STAFF REPORT

TO: Planning Commission
 FROM: Curtis Hindman, Interim Community Development Director
 DATE: 5/10/2023
 RE: Site Plan Approval– Village West, Lot 1, Current Zoning – GC
 Not located within an overlay district

SITE PLAN
 FOR
 A A SENOIA PROPERTIES, LLC
 VILLAGE WEST COMMERCIAL - LOT 1
 LAND LOT 247 - 1st DISTRICT
 CITY OF SENOIA - COWETA COUNTY
 SITE PLAN

SHEET
C1.1

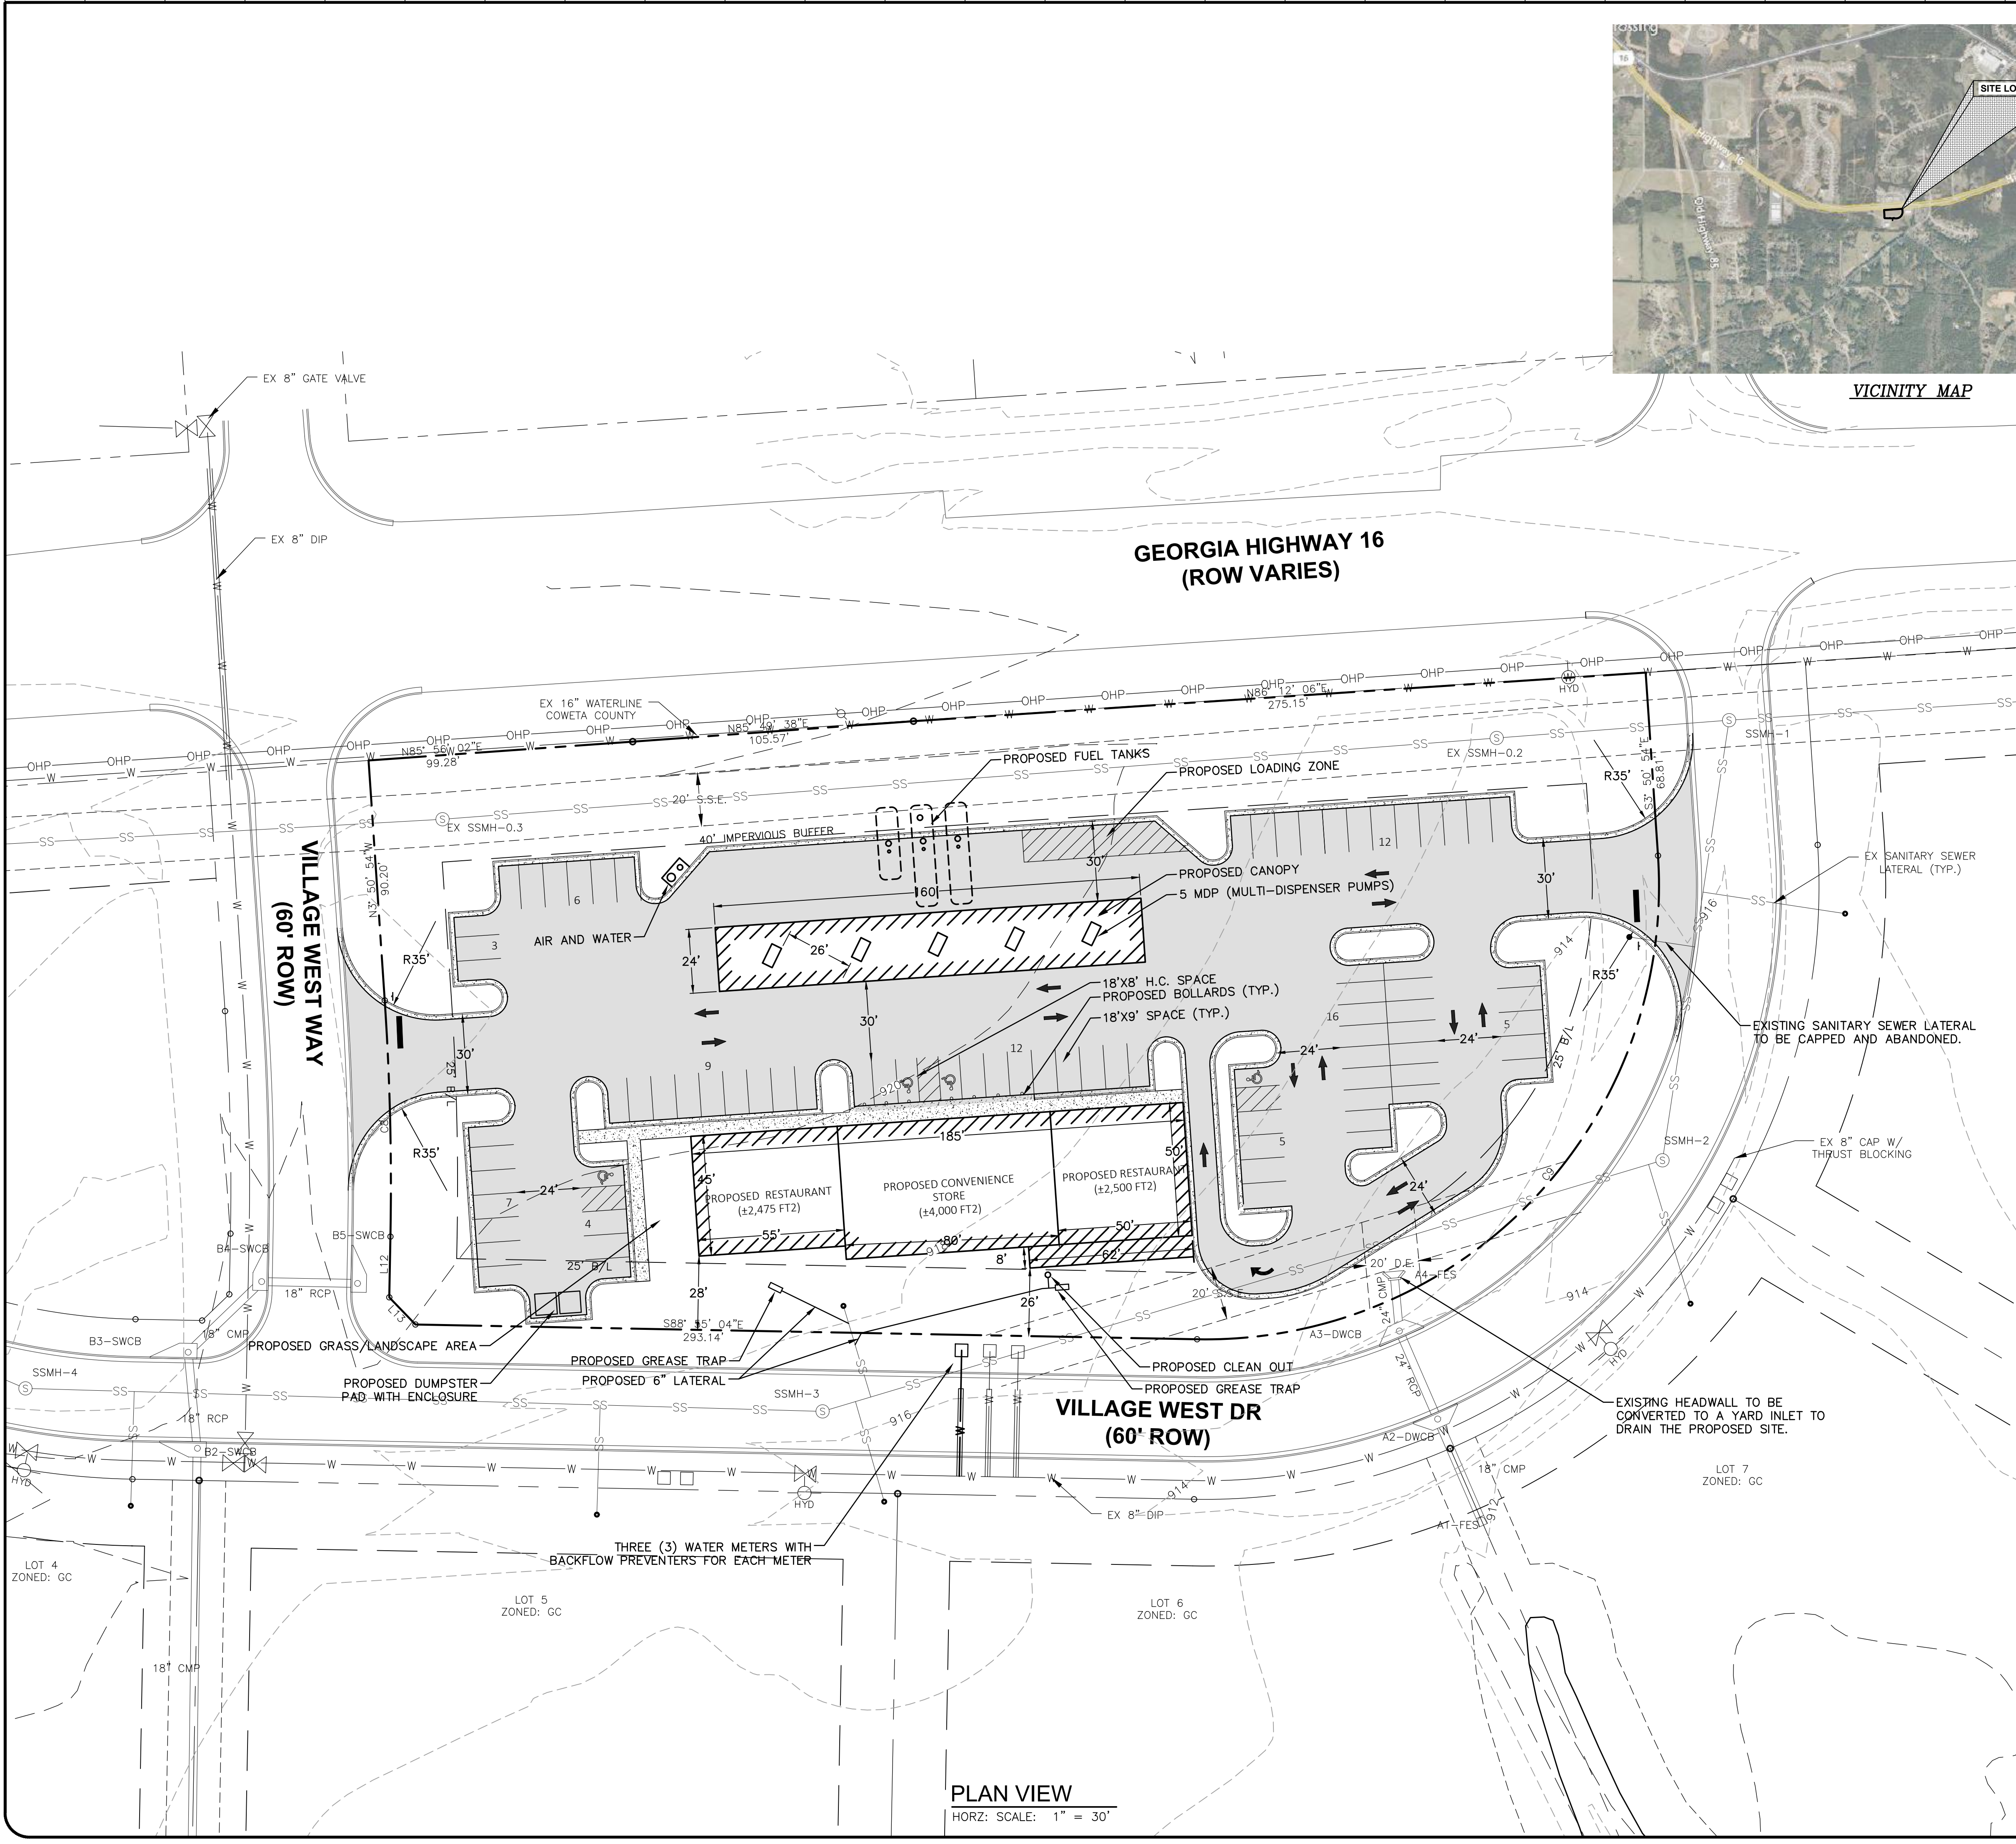
The site meets the minimum requirements for site plan approval as documented in checklist below. At this time a tree protection plan or landscape plan have not been provided but are required prior to land disturbance approval.

restaurants and one drive thru	previously approved 8/15/2022
Location of sanitary sewage disposal if applicable.	yes	
LANDSCAPE PLAN REQUIREMENTS (CHAPTER 40, SECTION 40-229) A landscape plan is required for any development in Senoia other than the development of individual lots for single-family residential purposes:		
A landscape plan shall include one canopy tree with a minimum trunk caliper of two and one-half inches (at four inches from the ground) for every 1,000 square feet of permanently disturbed area on the site. An area is considered permanently disturbed if it is covered with a building, structure, or other impervious surfaces like walks, drives and patios.	no	Landscape plan not provided at this time.
A landscape plan shall include one understory tree with a minimum trunk caliper of one of one inch (at four inches from the ground) for every 1,000 square feet of permanently disturbed area on the site.	no	Landscape plan not provided at this time.

<p>Landscape buffer along Collector Roads – per tree protection ordinance Article V, Chapter 30.</p> <p>These roads are Rockaway Road, Highway 16, Highway 85, Stallings Road from city line to Matthews Street, Pylant Road from city line to Clarke's Street, Rockhouse Road, and Luther Bailey Road.</p>	<p>No</p>	<p>Site fronts on Hwy 16 and would therefore be required to preserve or establish a 50 foot buffer or a reduced buffer. No buffer provided due to the sanitary sewer easement</p>
<p>The required tree-save/landscape buffer for any nonresidential property may be reduced as follows, subject to the approval of the city landscape architect and the planning commission:</p> <ul style="list-style-type: none"> A. Buffer may be reduced from ten feet, provided the developer installs additional landscaping that amounts to at least ten-percent of the caliper inches of the trees required for the entire site by the landscape ordinance. B. Buffer may be reduced from 15 feet, provided the developer installs additional landscaping that, amounts to at least 15 percent of the caliper inches of the trees required for the entire site by the landscape ordinance. 	<p>Even with a reduction allowed in ordinance this will not be able to be met due to conflicts with existing sanitary sewer easement</p>	<p>A variance may be needed to reduce the buffer along Hwy 16.</p>

Trees (d.b.h.) saved on this site plan:	None	No tree protection plan provided at this time.
Required Tree Density provided on this site plan: 80 D.B.H inches per acre (not including stream buffers)	No	No landscape plan provided at this time

The next step will be for the applicant to submit construction drawings which will include landscape plans for land disturbance permit approval.
